Submission by Nev Goodyer

June 19<sup>th</sup>, 2025

Having coordinated the actions of the Stockland Neighbours Action Group, this “personal” submission emphasises my own thoughts, most of which are common with the group.

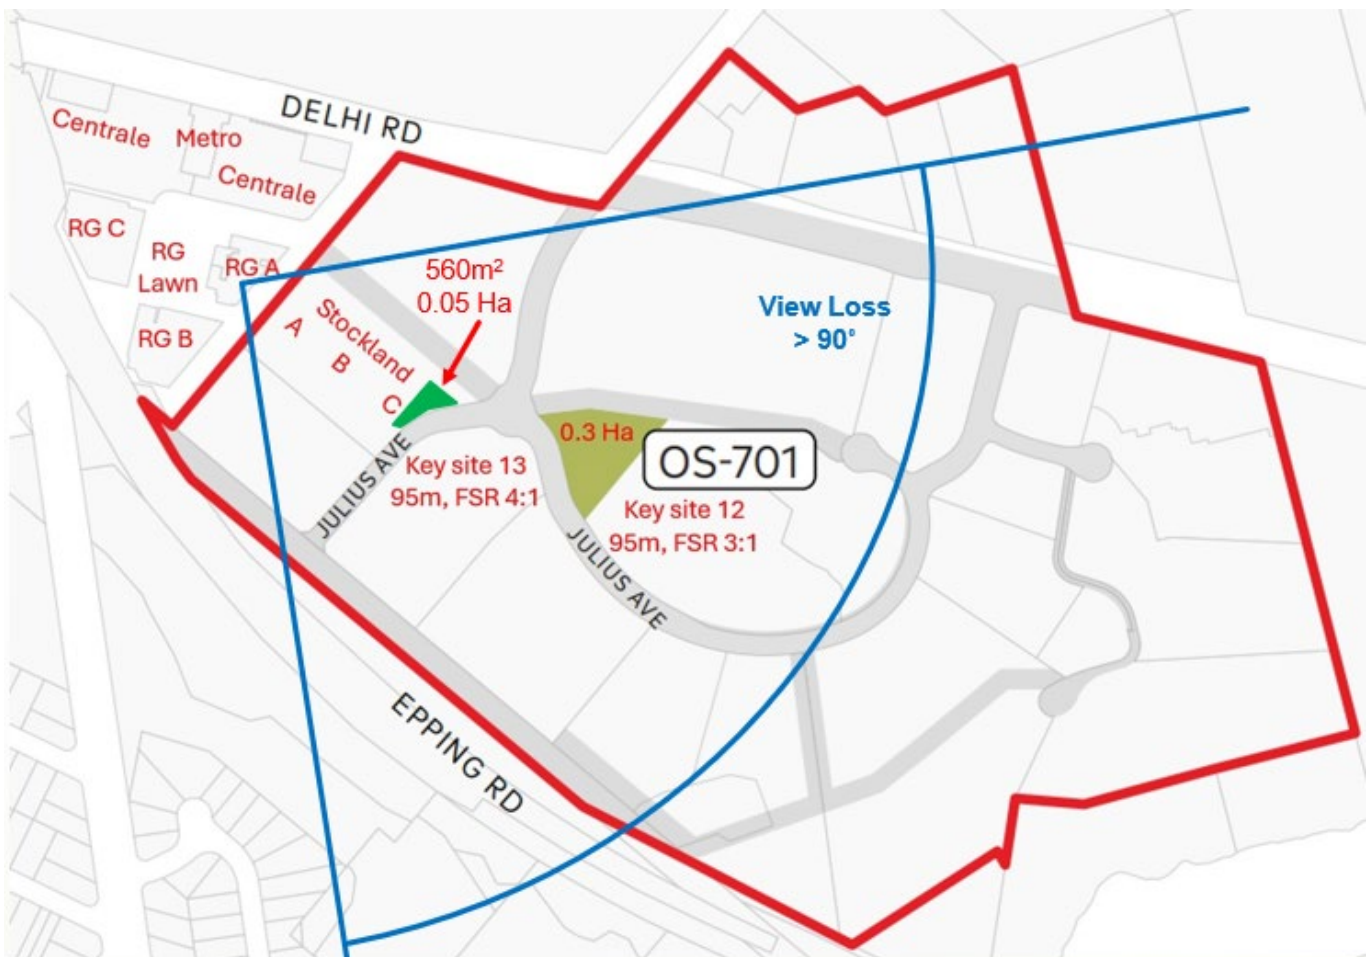
- The public **TOD Recreation area of 0.3ha** must service two 95m towers as well as Stockland.
- Level 3 & 10 areas are labelled as “communal”, but are they “Public”? (P’s 4&8, Appendix E - Architectural Plans Part 2:  
<https://majorprojects.planningportal.nsw.gov.au/prweb/PRRestService/mp/01/getContent?AttachRef=EXH-62637965%2120240722T072828.846%20GMT>)
- Stockland claims 50% of their 2955m<sup>2</sup> (0.3Ha) open space will receive mid-winter solar access.
- The **560m<sup>2</sup> of deep soil recreation area to the east of the building will receive minimal sunlight.**

Diagram from P2, Appendix E - Architectural Plans Part 2

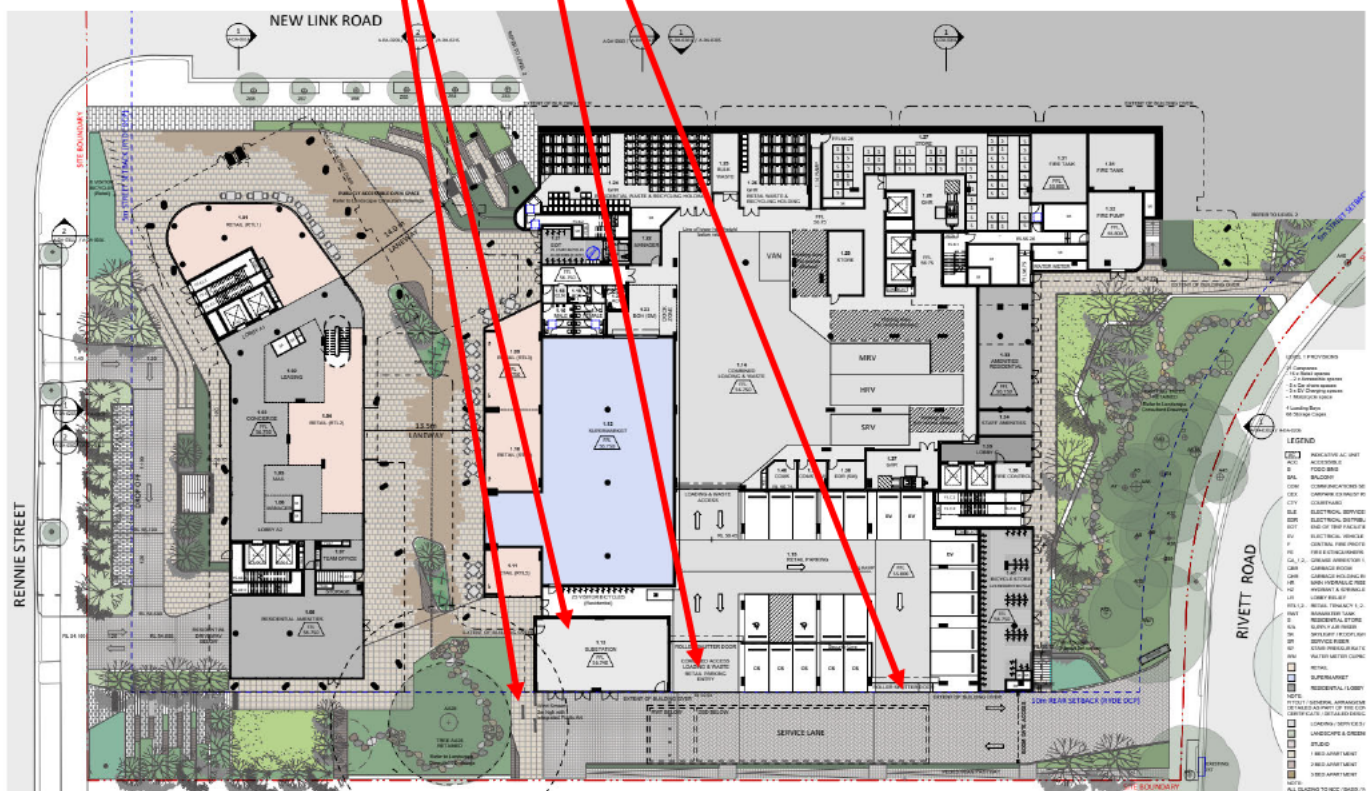
- **The East-West connectivity is disjointed** and presents a convoluted path of travel between Rennie and Rivett Roads, whilst **requiring the public to travel along the service lane, directly adjacent to:**

- **the retail parking exit.**
- **the waste loading area.**
- **a substation.**
- **wind screens.**

Diagram from TOD webinar

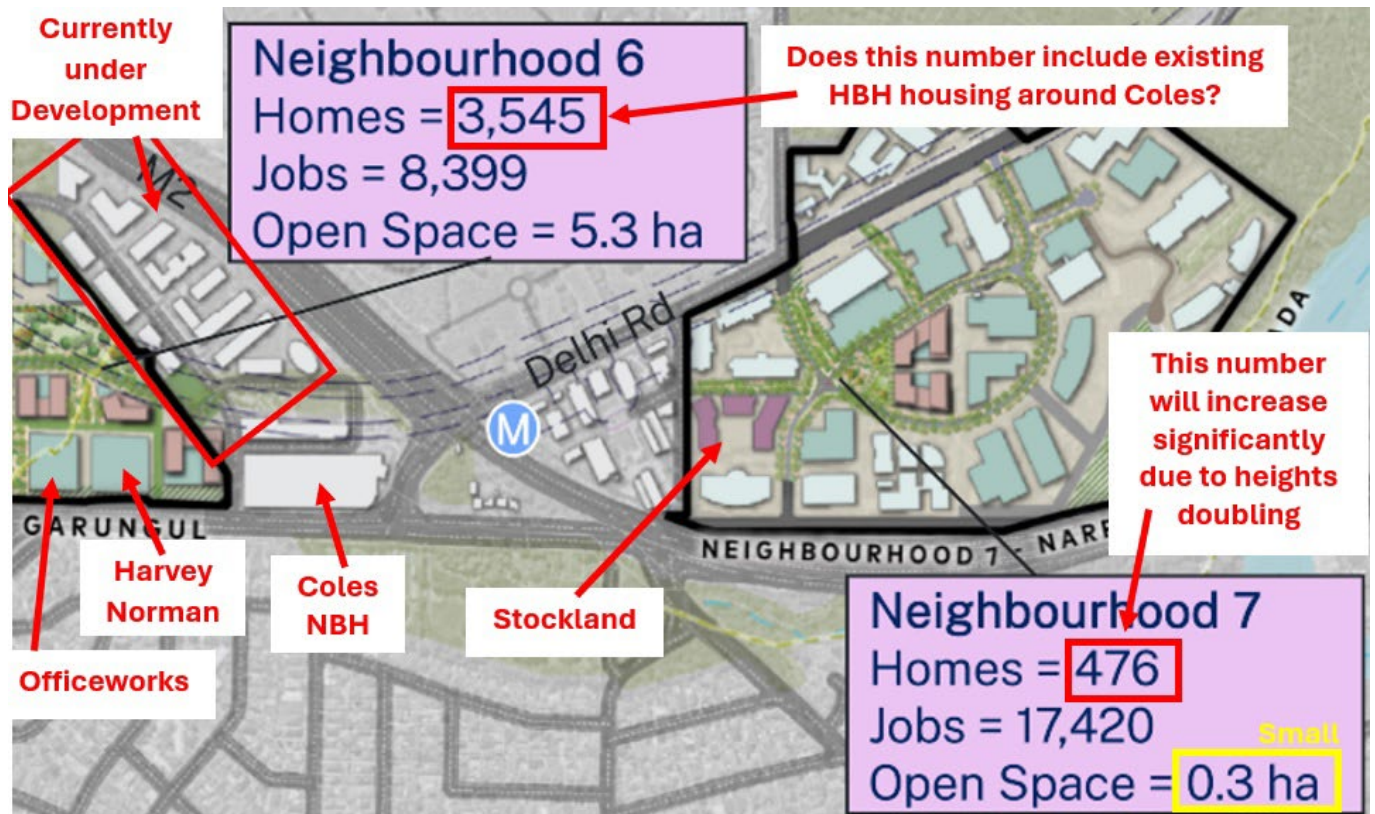
- Neighbourhoods 6 & 7 both use North Ryde Metro Station – **trains are already too full to take on passengers in peak periods.**
- TOD exhibited densities have been exceeded.
- Population of Neighbourhood 6 is set to rapidly increase with construction started.
- Population of Neighbourhood 7 will have many more homes than outlined here due to the two 30 floor towers in Key sites 12 & 13.

Image from P19, Response to Submissions Design Report (Appendix F - Architectural Design Report Part 1):

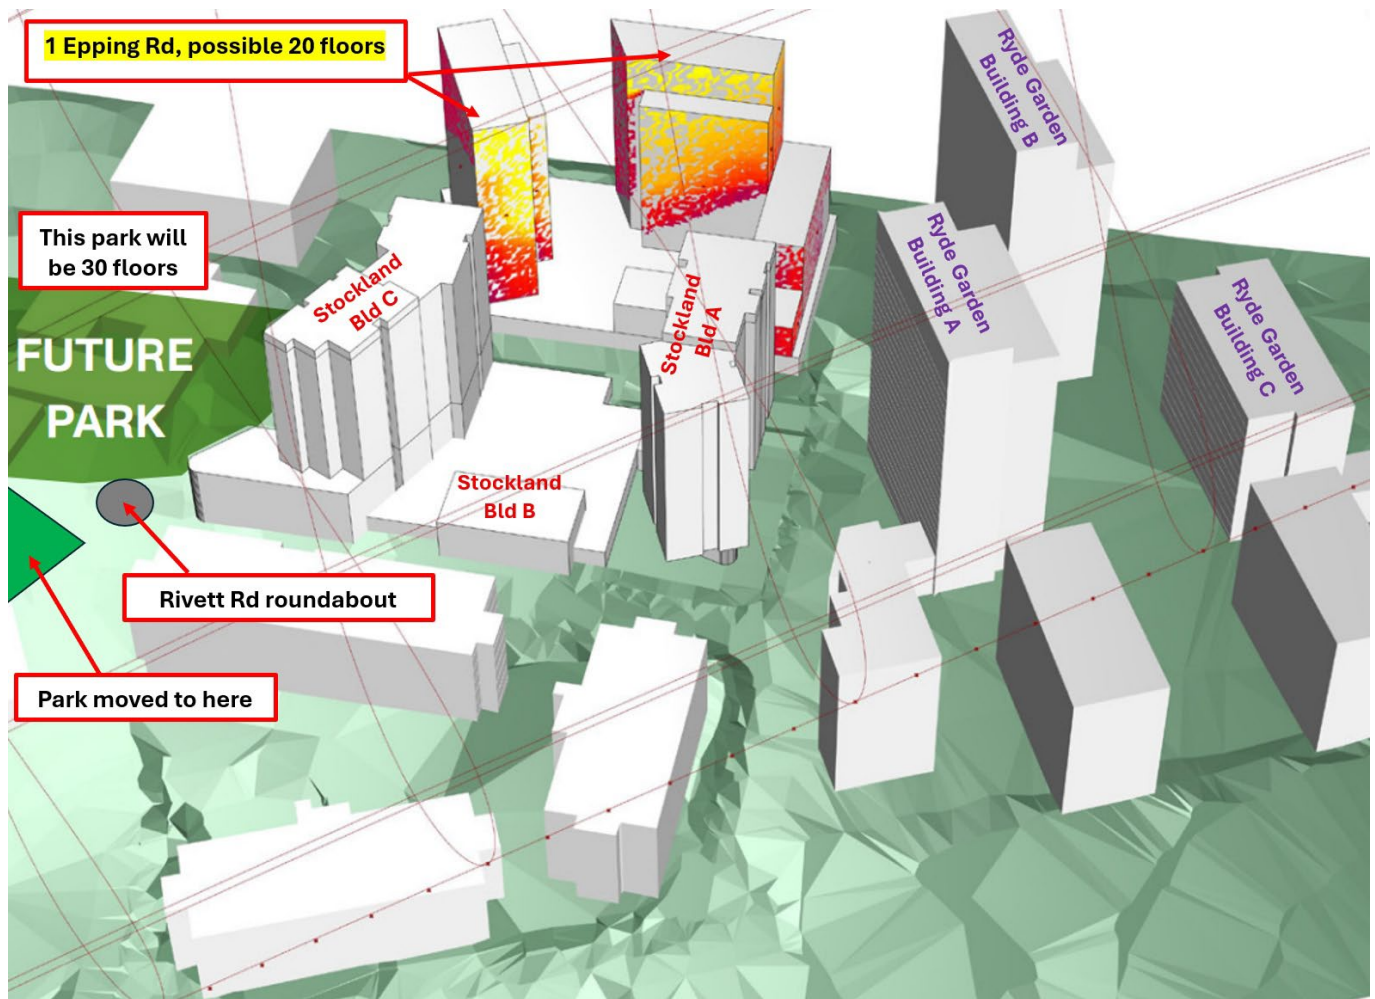
- If Stockland is deemed to satisfy Clause 7.7 (6.9), **Goodman's 1 Epping Rd site appears ready to rise to the same height.**

- Note that the image above shows Stockland's amended plans have not taken into account the **TOD park location change**.

Screen shot from time lapse video, viewable at: [20240915\\_N9-512-Lapse-E-Sunset-Cloudy.mp4](#)

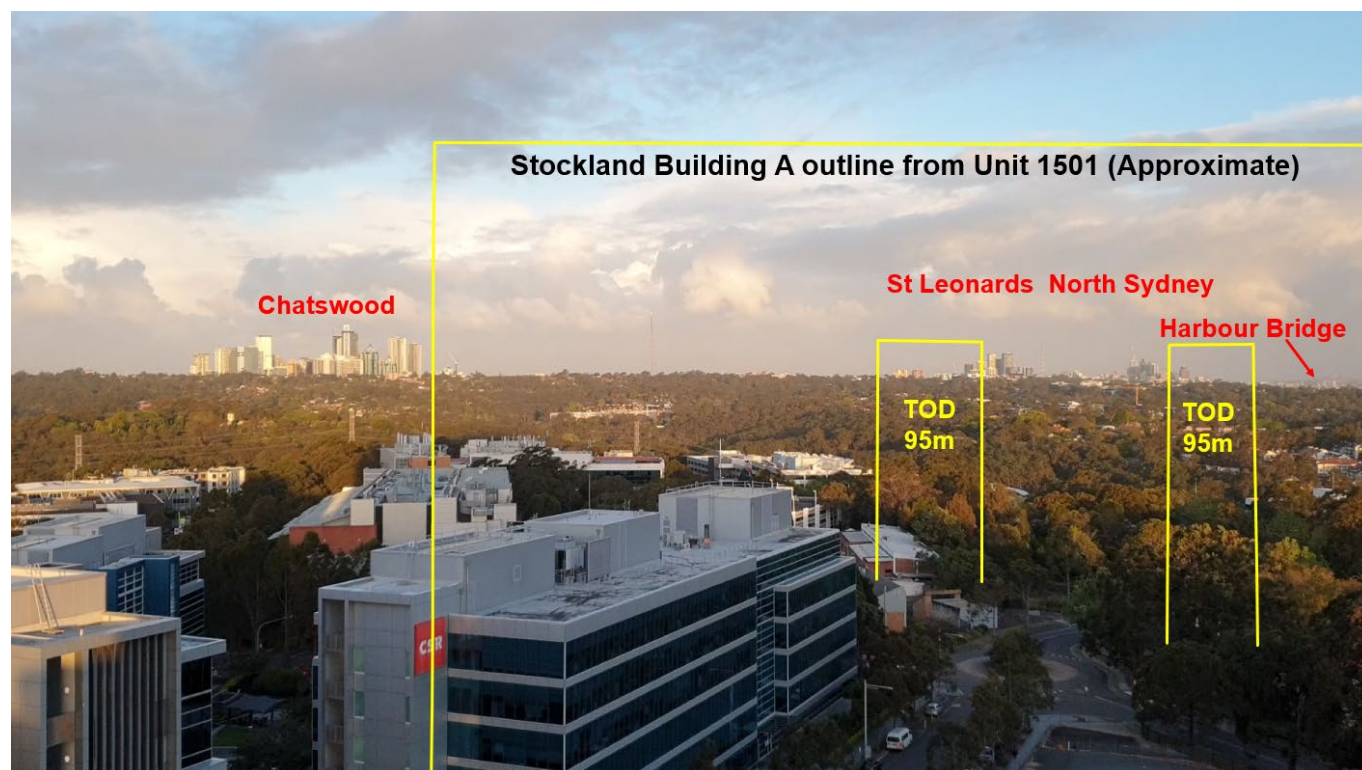
Another image, taken from a sunset video shown to the IPC panel, shows the approximate outline of the Stockland Building compared to the “view sharing” offered by the two TOD 95m towers planned under the TOD rezoning.

### 5.2 CAMERA POSITION 02 - RYDE GARDENS, 1 NETWORK PLACE, RL121.0

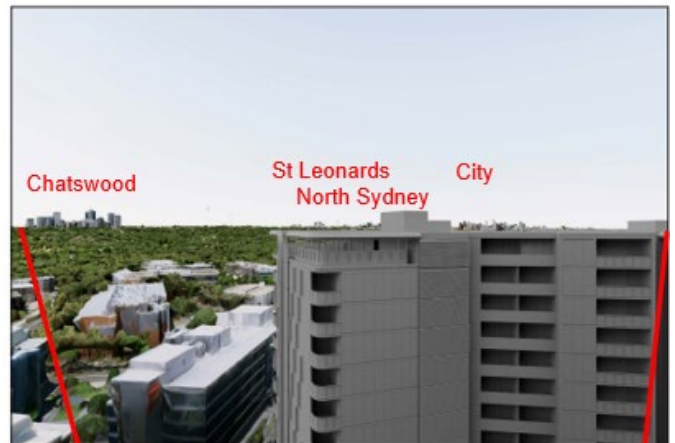
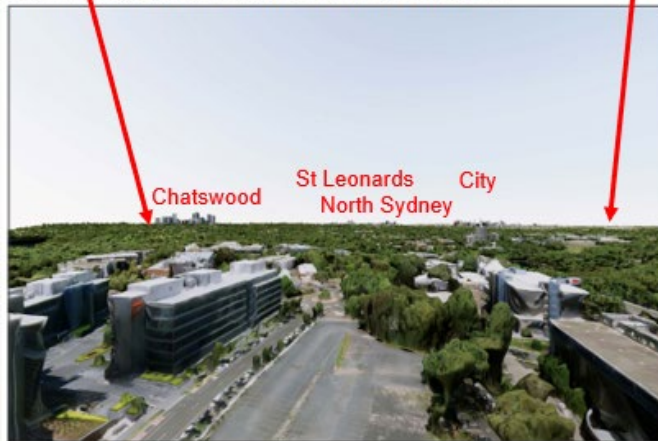
- Is the **ALMOST TOTAL!** view loss in the bottom right image “Moderate” or “**Devastating**”?
- Views from Camera 3 are with a much wider-angle lens, minimizing the view loss.
- Arrows and block outs attempt to make the images comparable.

The base diagram is from P26 of the DPHI Assessment Report:

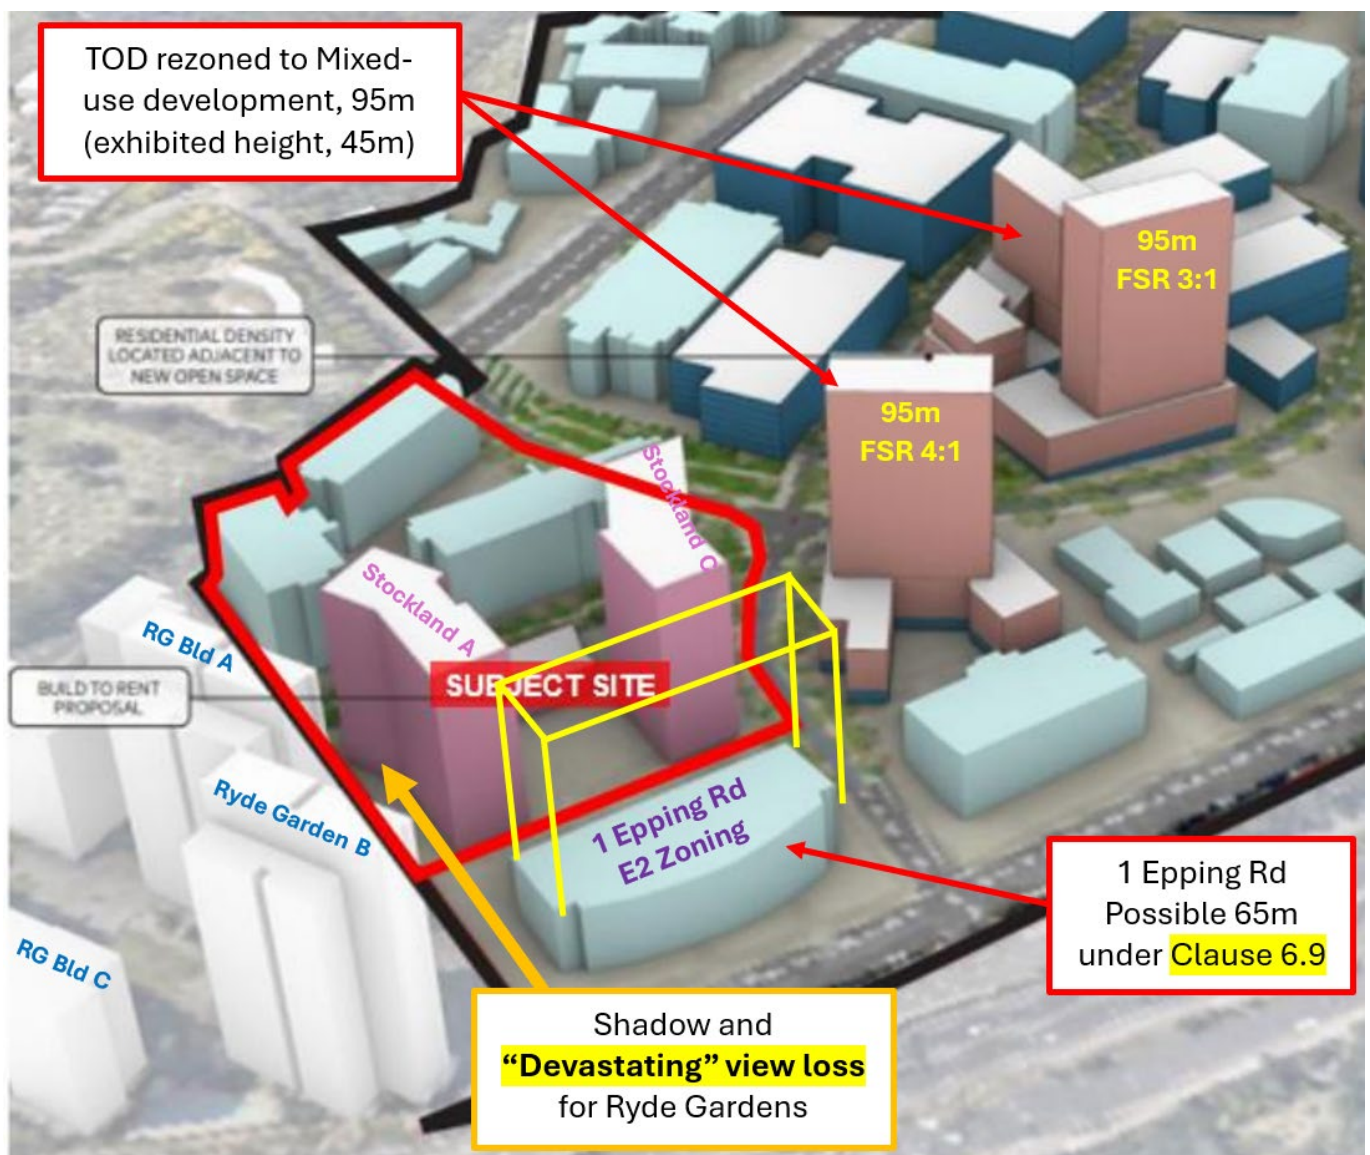
- A development **compliant, with all planning controls** would be considered more reasonable.
  - **Compliance relies on Clause 7.7**
  - and **transfer of GFA from Trinity Stage I**
- View loss is **“Devastating”**, not **“Moderate”**.
- **“Skilled Design”** would not extend from corner to corner
- The RtS purports that Stockland’s Building A is **“a mid-distance townscape element”**! (P5, RtS) <https://majorprojects.planningportal.nsw.gov.au/prweb/PRRestService/mp/01/getContent?AttachRef=EXH-62637965%2120240722T072824.566%20GMT>

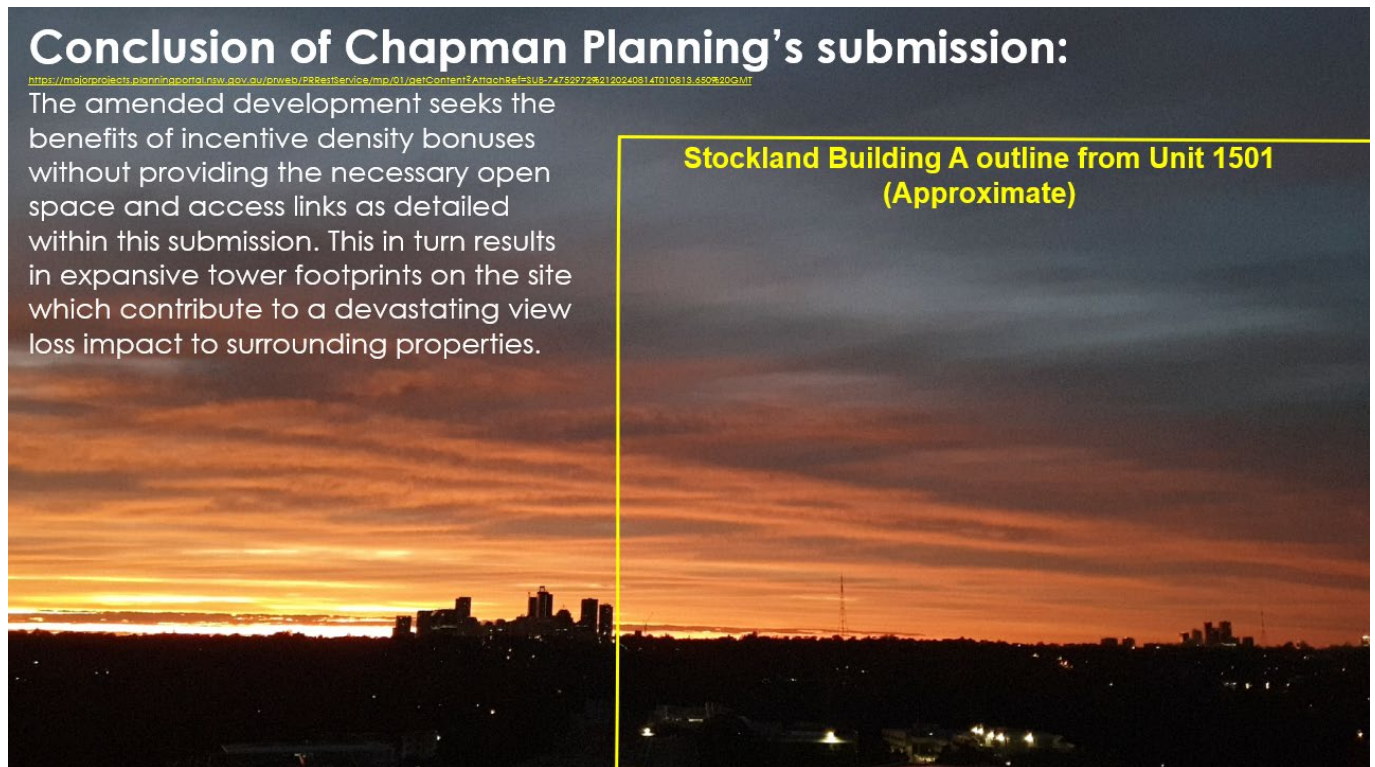
- P33 Government Architect NSW - Built Form, Ground-Plane and Public Domain
